Proposed City Plan 2030

Errata note

Proposed Plan Written Statement - Table 6

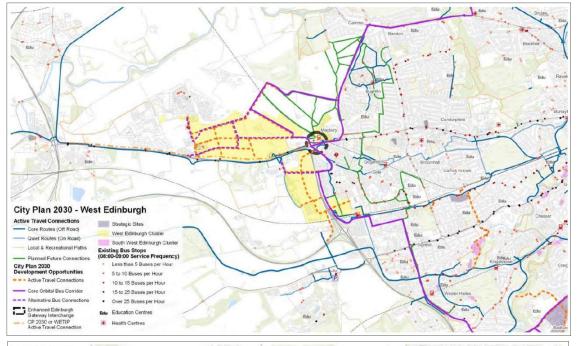
Clarify the route description of 'PT6: North South Orbital bus connection - Bankhead - Edinburgh Park to Craig's Road' by rewording to: 'North South Orbital bus connection - Bankhead - Edinburgh Park to Maybury Road'

City Plan 2030 Transport Assessment September 2021: Figure 5.26: West Edinburgh Committed and Potential Development Infrastructure

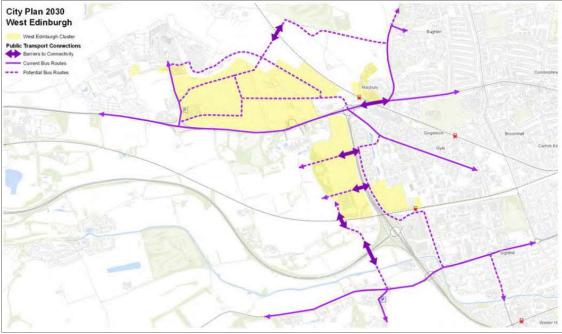
Amend the route of the public transport proposal for an orbital bus route 'PT6 North South Orbital bus connection' and the 'West Edinburgh Improvement WE16: Improved northern and southern orbital bus routes from Maybury (via Maybury Rd and Edinburgh Park respectively)', to follow the route shown in the City Plan 2030 Transport Assessment, September 2021 that accompanies the Proposed Plan as a background document.

See 'Figure 5.26 West Edinburgh Committed and Potential Development Infrastructure' and 'Figure 5.27: Creating Interconnected Neighbourhoods – New and Improved Public Transport Connections' (next page).
